RUSSELL & PAMELA WOODSON SUBDIVISION

APPLICATION NUMBER 11 DATE May 6, 2010

REQUEST Subdivision

DETAIL SITE PLAN

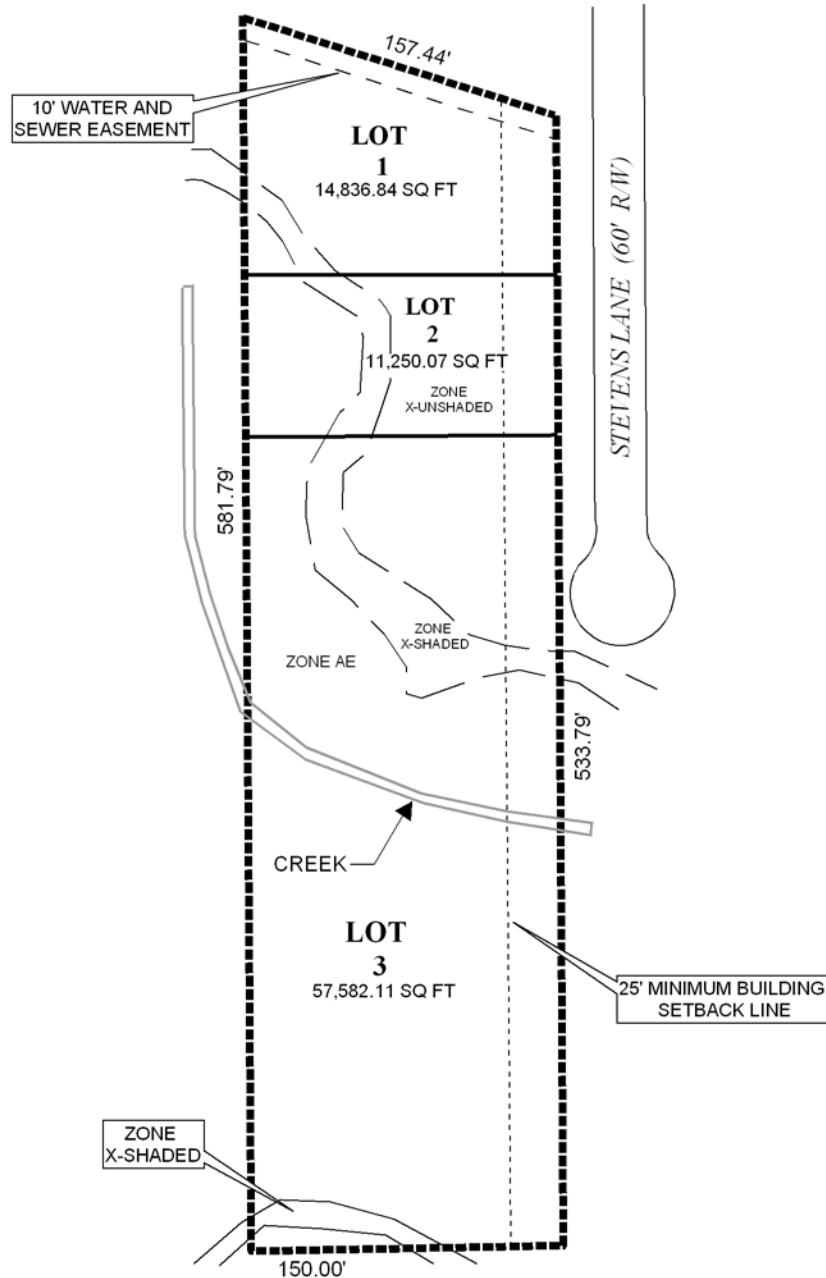
The site fronts Stevens Lane, a cul-de-sac minor street with a complaint 60' right-of-way. However, the cul-de-sac is substandard in that it does not meet the 2003 IFC standard 120' diameter; therefore dedication should be required to provide a 60' radius, centered 60' North of the South terminus of Stevens Lane. As a means of access management, a note should be required on the final plat stating that each lot is limited to one curb cut, with the size, location, and design to be approved by Traffic Engineering and conform to AASHTO standards. As on the preliminary plat, the final plat should illustrate the 25' minimum building setback line but revised to be set back around the dedicated cul-de-sac radius. The lots are labeled on the plat with sizes in square feet; this should be revised to label each lot with its size in acres and square feet, or a table should be furnished on the final plat providing the same information.

As proposed, Lot 3 would exceed the maximum depth-to-width ration of Section V.D.3. of the Subdivision Regulations; however, this would be a decrease in the existing ratio of the parcel

toward a more compliant one. Furthermore, the presence of a creek, associated floodplains, wetlands, and the termination of Stevens Lane would make it nearly impossible to bring proposed Lot 3 into compliance. Therefore, a waiver of Section V.D.3. would be in order.

The plat indicates the 10' water and sewer easement within the property at its North end, but does not indicate the easement adjacent to the West side of the property. This should also be shown on the final plat.

- 1) dedication of sufficient right-of-way to provide half of a 60' radius cul-de-sac, centered 60' North of the South terminus of Stevens Lane;
- 2) placement of a note on the final plat stating that each lot is limited to one curb, with the size, location, and design to be approved by Traffic Engineering and conform to AASHTO standards;

- 3) illustration of the 25' minimum building setback line along Stevens Lane, revised to show a setback around any dedicated cul-de-sac radius at the South terminus of Stevens Lane;

- 4) labeling of each lot with its size in both square feet and acres, or the furnishing of a table on the final plat providing the same information;
- 5) illustration of both the easement within the property at its North end, and the easement adjacent to the property along its West side;
